# PLANNED DEVELOPMENT PRELIMINARY PLAN

► **FILE #:** 2-A-23-PD

► **Approve the preliminary plan for the Galbraith School Adaptive Reuse planned development, including approval of the requested exceptions to the underlying zoning's dimensional and use standards, subject to 6 conditions.**

# GALBRAITH SCHOOL ADAPTIVE RE-USE

SHEET  
**G101**  
SITE PLAN + UNIT & SF

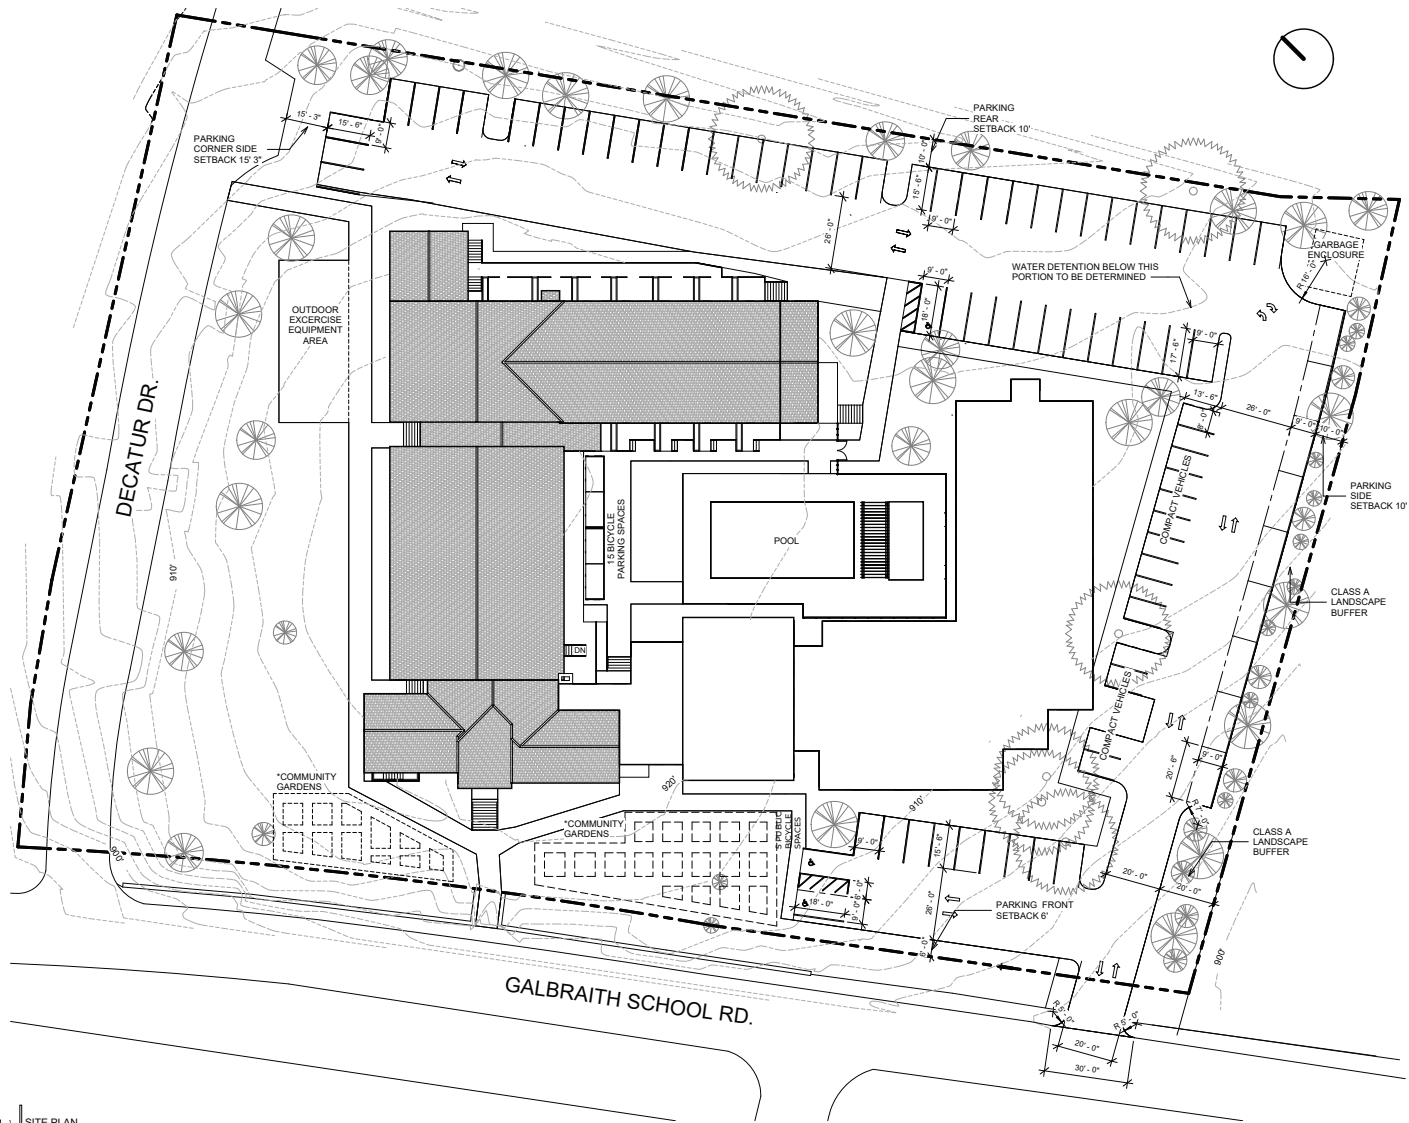
4. Confirming sight distance at the driveway access points during the final plan phase.

- b. Building height: Staff supports the increase in building height due to the lower floor elevation on the portion of the site where the new building is proposed. The top of the structure would be similar to that of the existing school building.

- c. Maximum building coverage: The proposed increase to 50% allows for the new building to fold into the existing building, creating a courtyard space and screening the parking lot along the rear of the site. Due to the site's proximity to South-Doyle Middle School and the other properties owned by Knox County along Galbraith School Road and Taylor Road, it is not on the side of the road with an established pattern of detached single-family residential dwellings.

- d. Maximum impervious surface: The majority of the parking will be screened by the buildings, and the project is adding public gardens and additional landscaping to offset the amount of impervious surface on the site.

- a. The zoning ordinance allows a 30% reduction in required parking spaces for sites within 1/4 mile of a transit line. This project proposes a more modest 15% reduction due to the slight increase in distance from a transit route over what would typically trigger the allowance of a reduction.

- i. 1/3 of a mile is still a walkable distance, so staff supports the proposed reduction in required parking spaces. This reduction provides flexibility in the event that the number of spaces required changes due to plan revisions or if unforeseen circumstances.

- ii. Additionally, the applicant has provided more accessible parking spaces than what would ordinarily be required due to the additional accessible dwelling units they are constructing beyond the minimum required. ADA parking spaces require more land area due to the loading areas to the side of the vehicle where another, standard-sized parking space could be located.
